Submission to Variation 2 Te Tai o Poutini Plan

Ken Wiltshire

Initial Submission 16 Dec 2024

This submission is related to the section of coast adjacent/abounding to SH67 between No 165 Torea St at Granity and No 11 Main Rd Ngakawau. Viz Section G5 as specified in TTPP Varn 2, p12, Table 3-1, Fig 3-1.

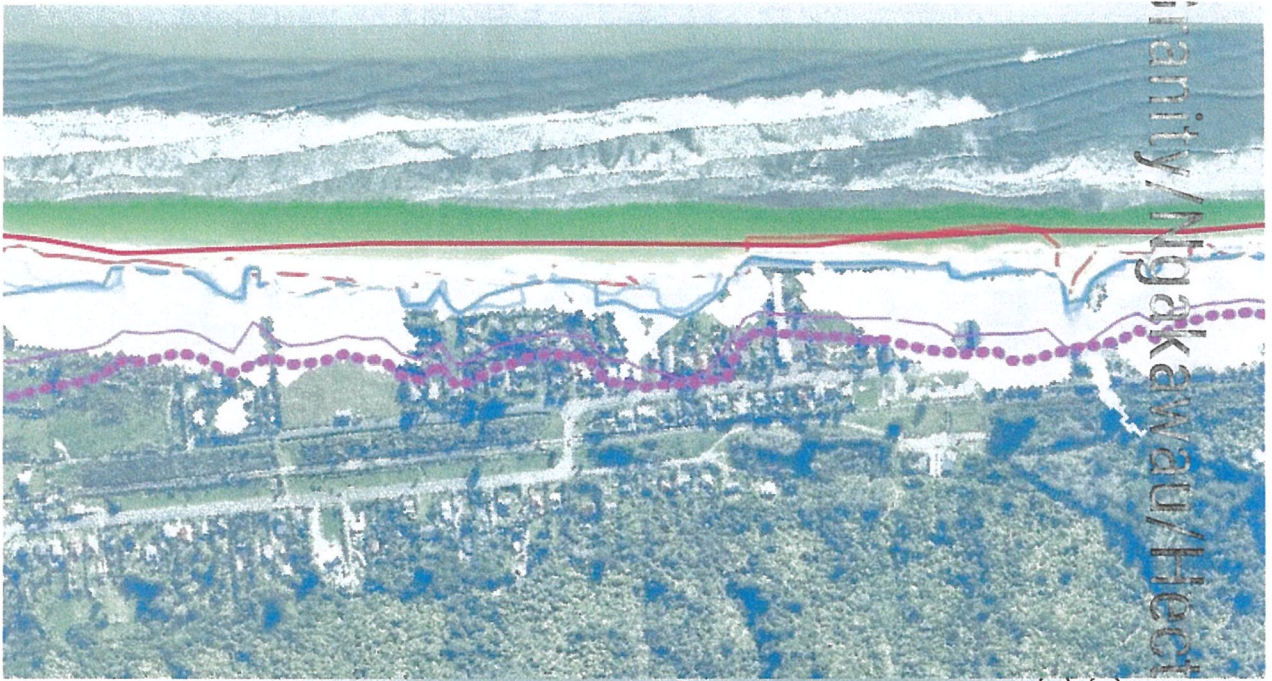
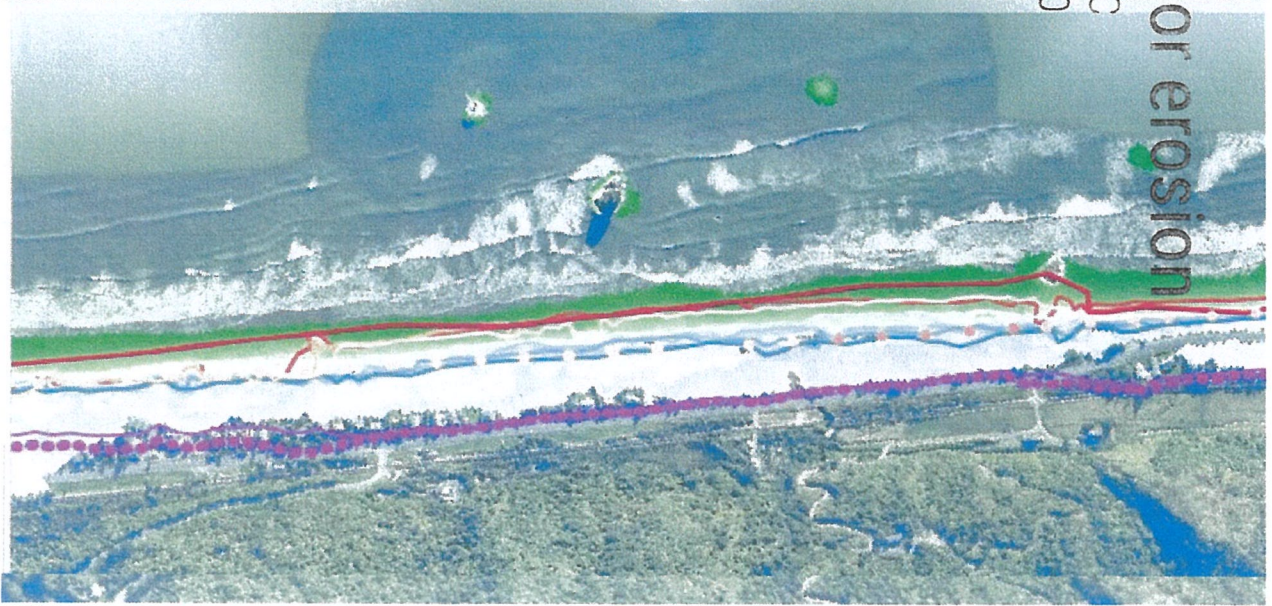
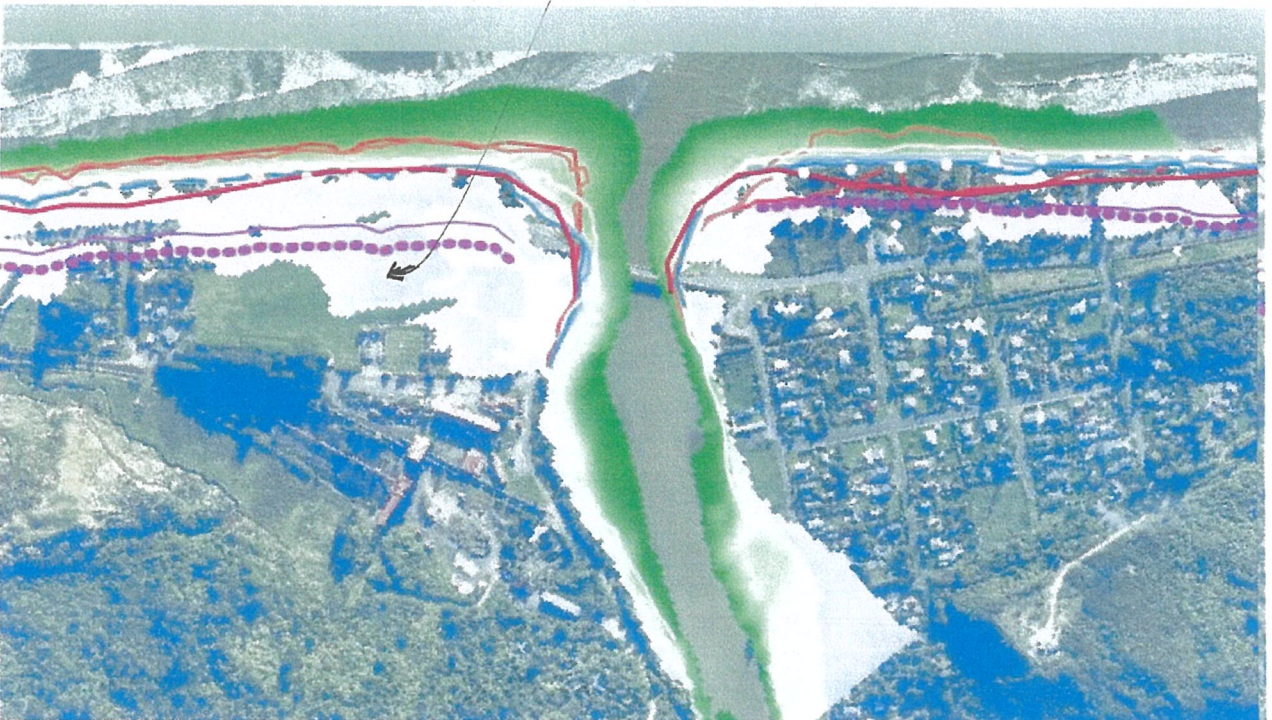
?

Full Inundation Projected ?

⊗
↑
No 8
Main Rd
